TENDER T-2025-42

Burgess 1 Dam Rehabilitation

DATE: November 14th, 2025

ADDENDUM #5

TYPICAL SECTION OF NORTH RETAINING WALL
SCALE: 1:40

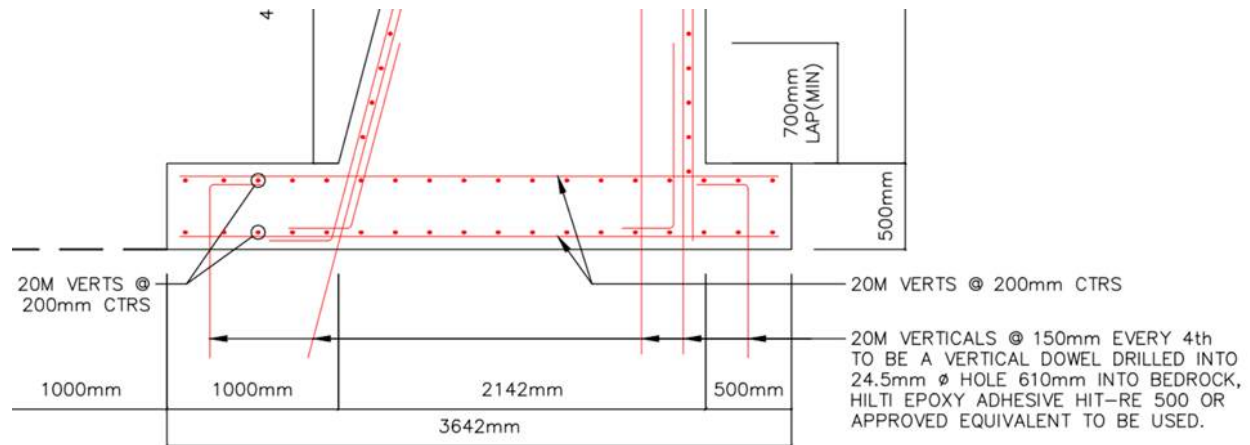
Q3. The answer provided for Q26 in Addendum 3 seems to be somewhat confusing. The note (on Drawing S2) indicates that the vertical 20M rebars are spaced at 150 mm, and every 4th vertical 20M rebar is to be drilled into 610 mm holes into bedrock (thus 3 vertical rebars don't need to be doweled, the 4th only is to be doweled). Please confirm that the required embedment into the rock is 150 mm rather than 610 mm as indicated below.

A3. This answer supersedes Addendum 3 A26: To clarify, vertical reinforcement for the downstream retaining walls is to consist of 20M vertical bars spaced at 150 mm. Every 4th set of bars (into the page) are to consist of Dowelling drilled into a 24.5 mm diameter hole and socketed into the competent bedrock 610 mm with Hilti epoxy adhesive or an approved equivalent as shown in the Contract Drawings.
